CORRIGENDUM - I

Tender Number: IREL/MK//ET/7/2026-27 dated 21.08.2026

Work Description: Request for Proposal (RFP) for selection of agency for installation of De-Sliming system at HUS (MK Unit) on Engineering Procurement Construction (EPC) Basis

HUS Flow sheet

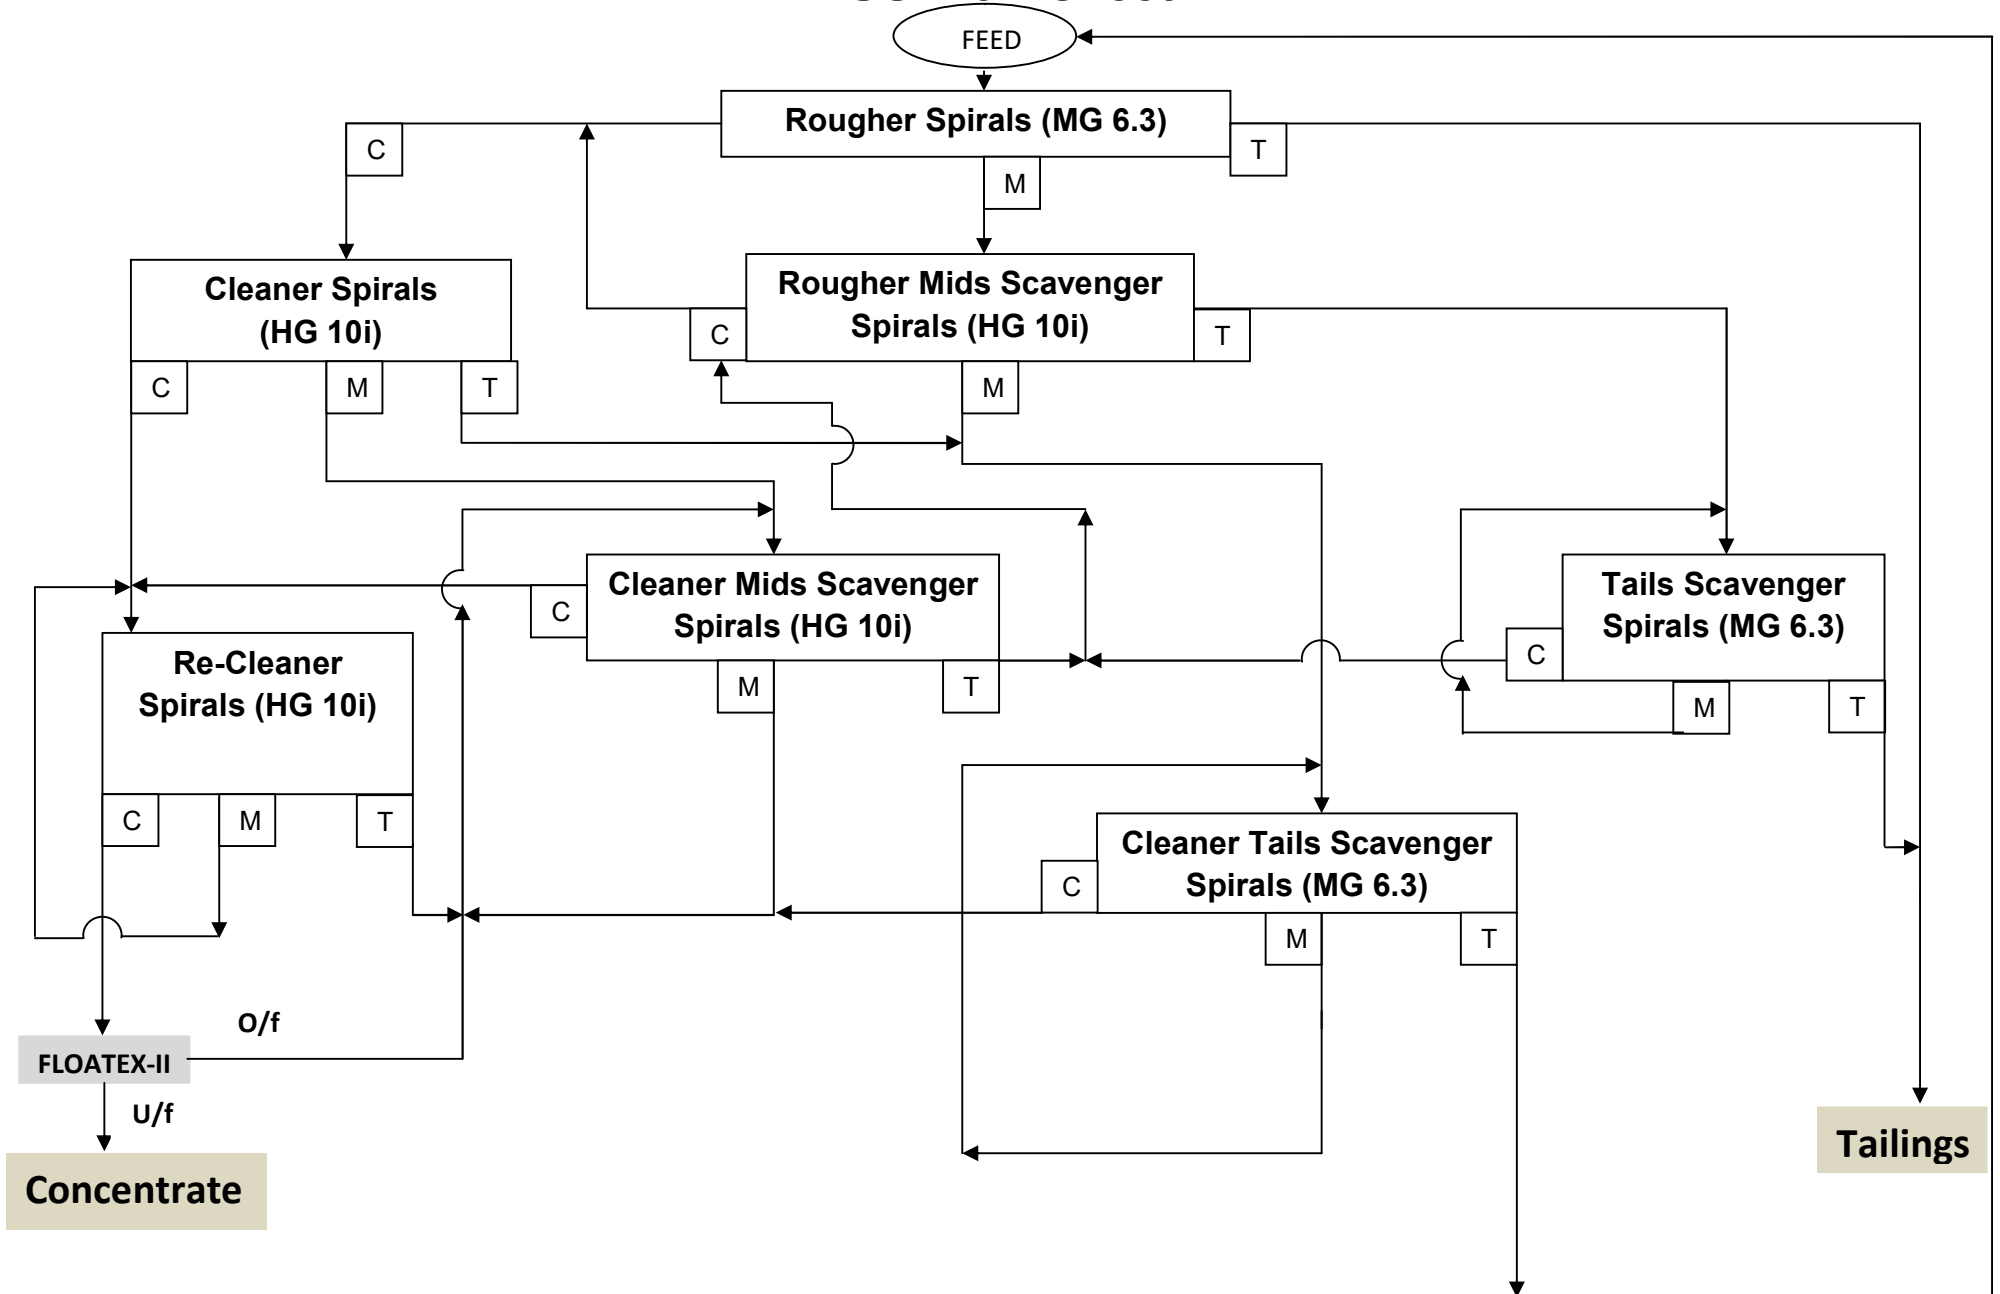
44.			Process Flow Diagram and Mass Balance Please provide a detailed Process Flow Diagram (PFD) showing: • Stream numbers • Flowrates • Solids percentages • Water balances • Mass balance information. This information is essential for verification of process equipment sizing and overall plant performance.	Process flow diagram is enclosed (Annexure-I, Pg 2/2).

which the existing drawings will be required	
124.	Process Block Flow Diagram		Process Block Flow Diagram is requested to understand the proposed addition and modification in the existing plant to cater desliming requirement of new feed	Process Flow Diagram is attached (Annexure-I).

Feed Characterization Data

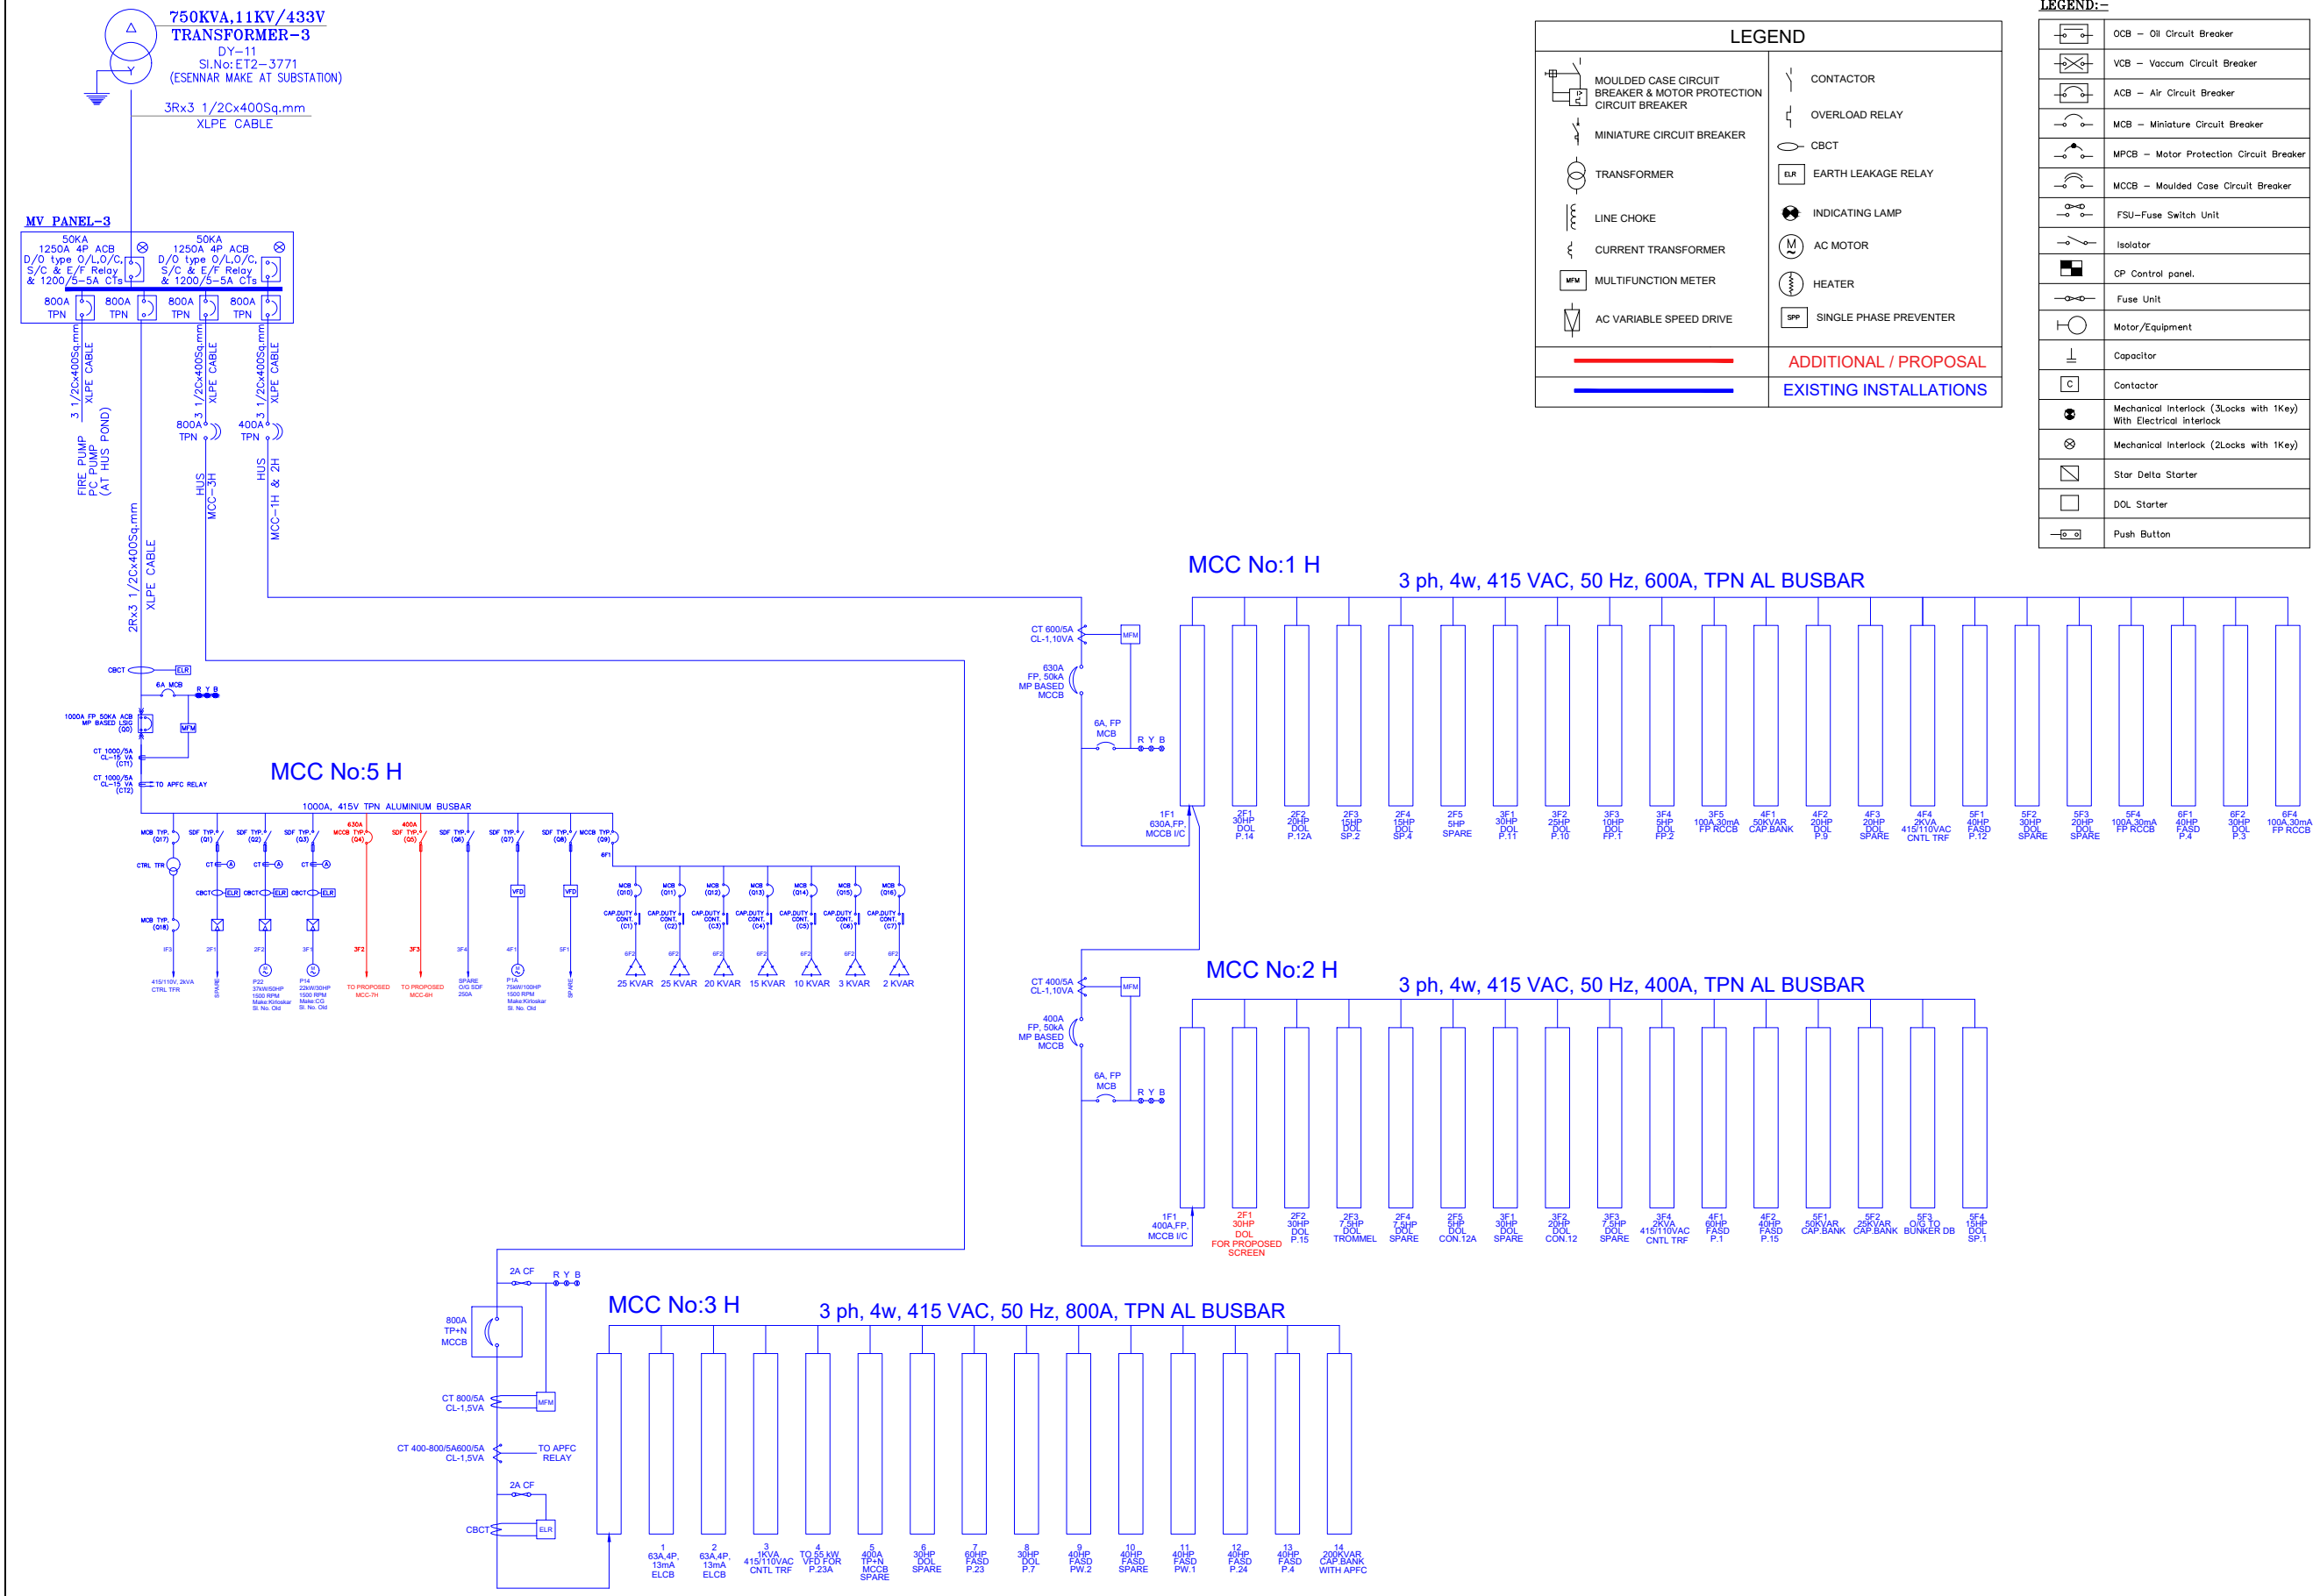
6.	-	-	Please provide detailed feed characterization data, including historical HM percentage, slime percentage, PSD and seasonal variations. Required for process design and equipment sizing.	Feed characterization data is attached (Annexure-II). There will not be any seasonal variation in the feed material composition.

Tie-In Data

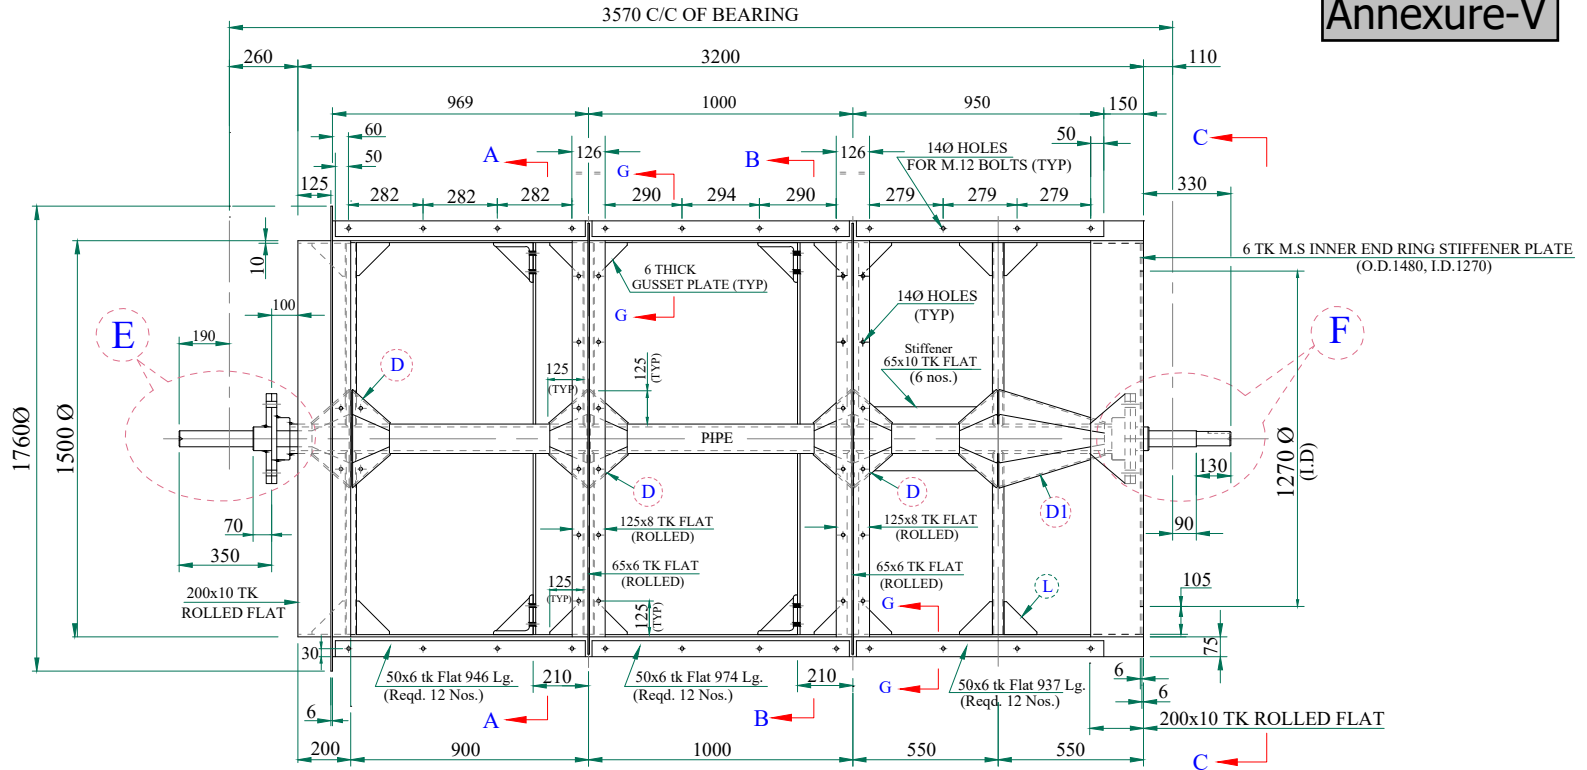
13.			Please provide data sheets and layout drawings of existing CPD tanks, pumps and associated equipment. Required for tie-in and hydraulic calculations.	The tie-in interface pump details are attached (Annexure-IV).
